FISH DISTRIBUTION DATABASE CATALOG/ATLAS
CORRECTION FORM

MAP: Seward 3-7

WATERWAY NUMBER: 244-30-10010-2225

NOMINATION NUMBER: 07-192

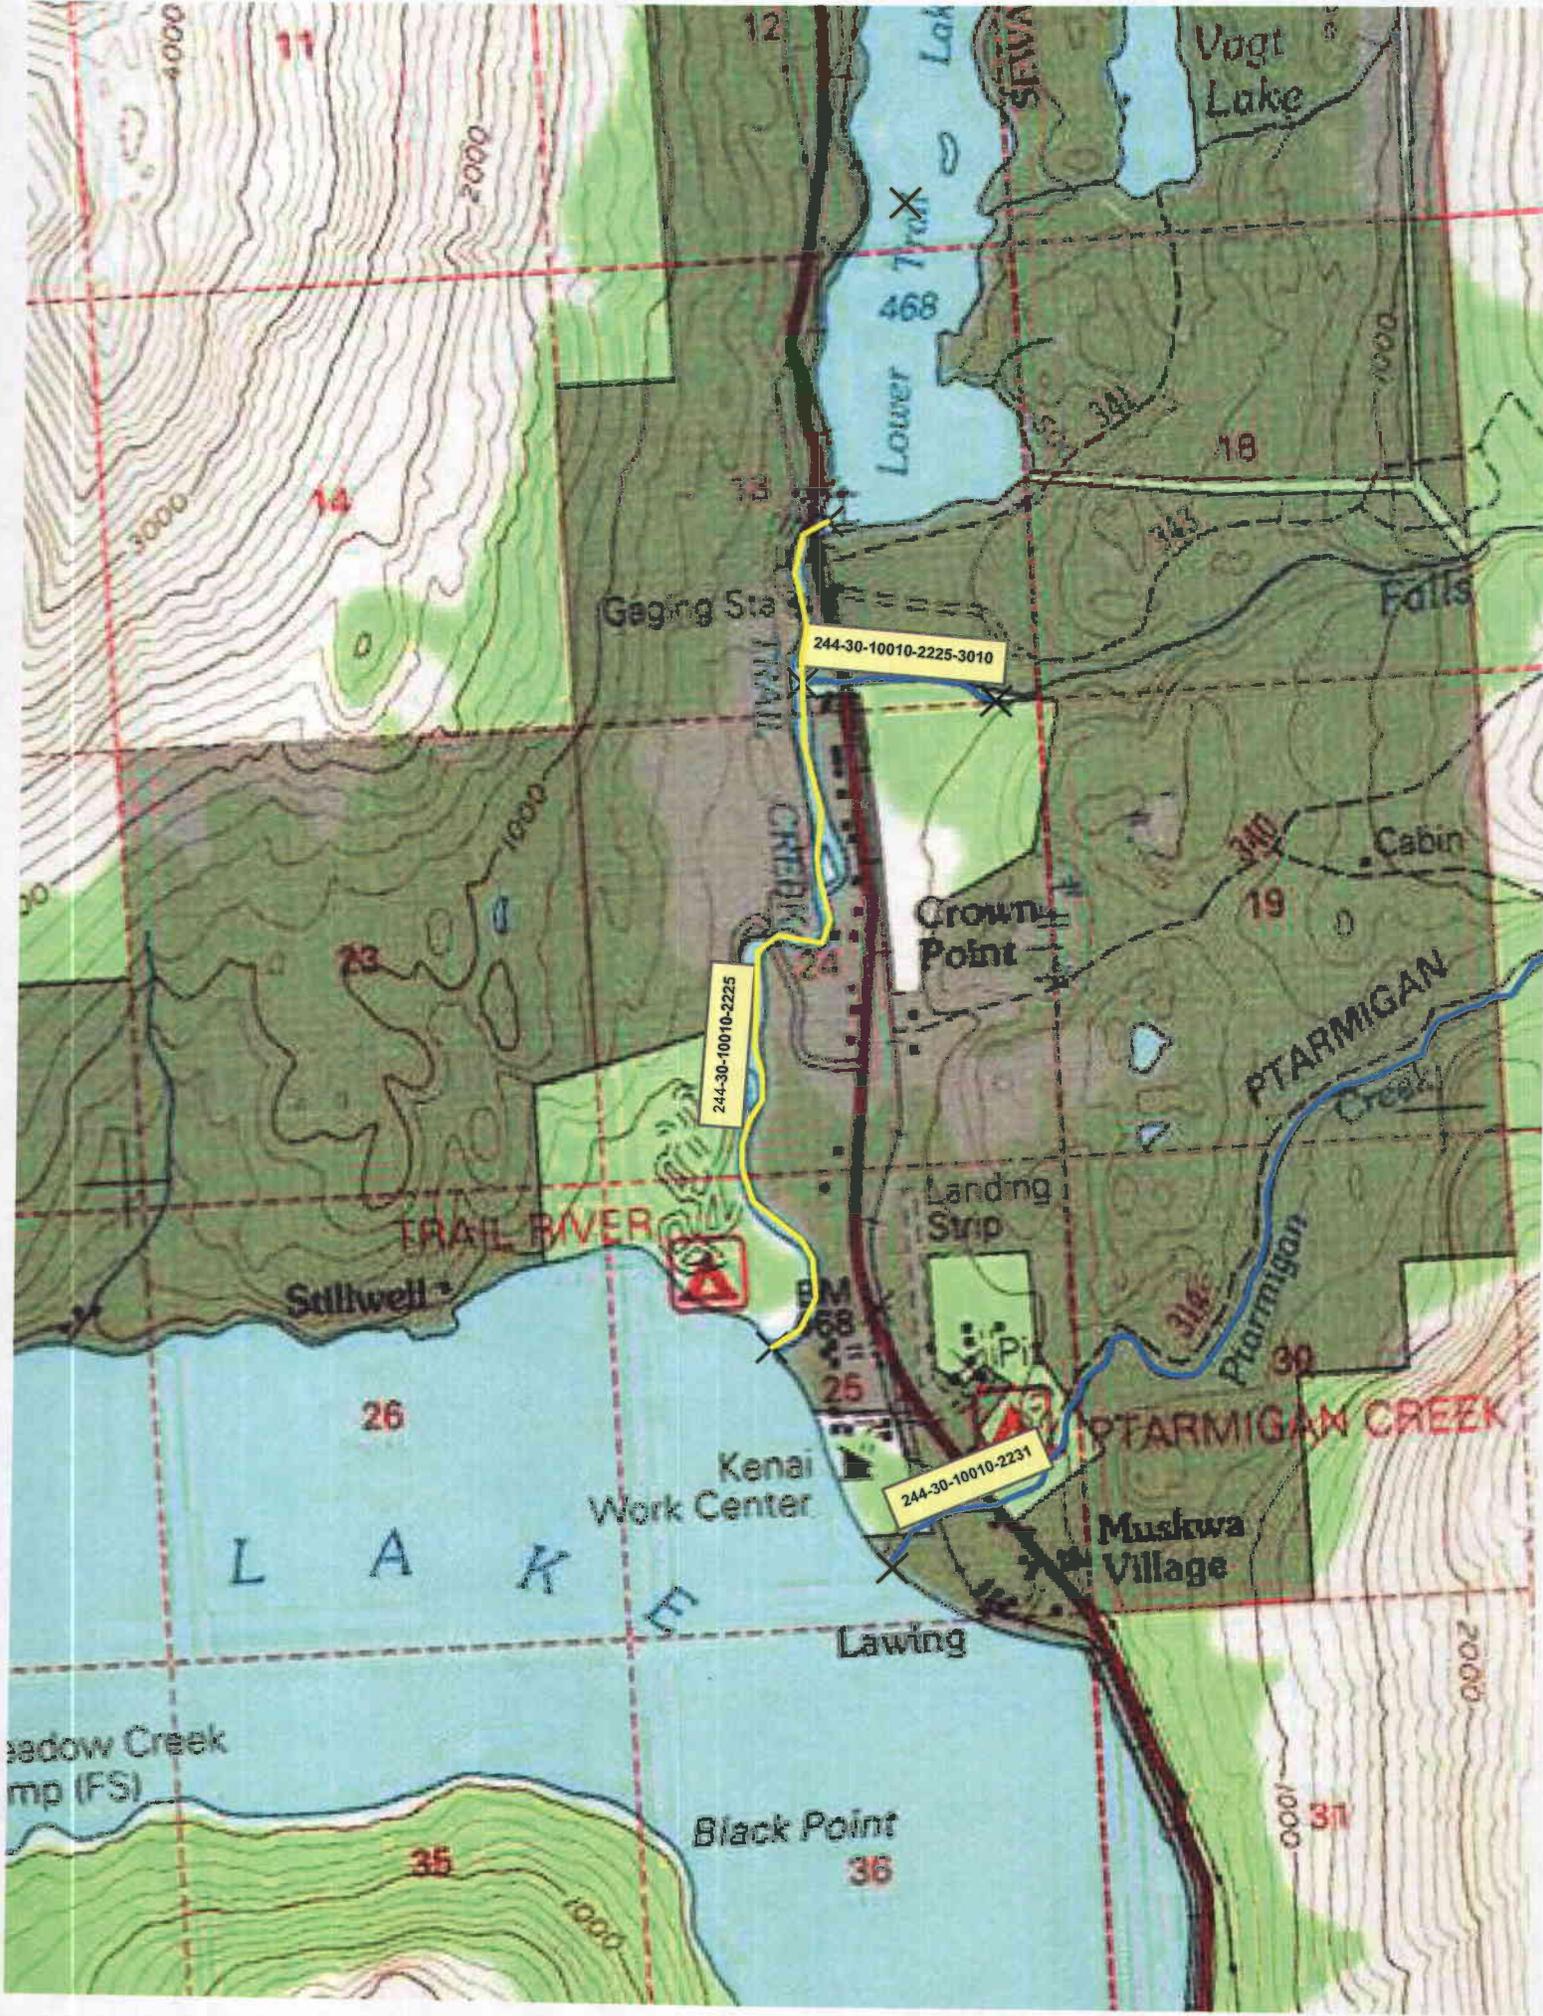
DESCRIBE CHANGE(S): Rename 244-30-10010-2225
AS "Trail Creek" current name
Trail River is incorrect.
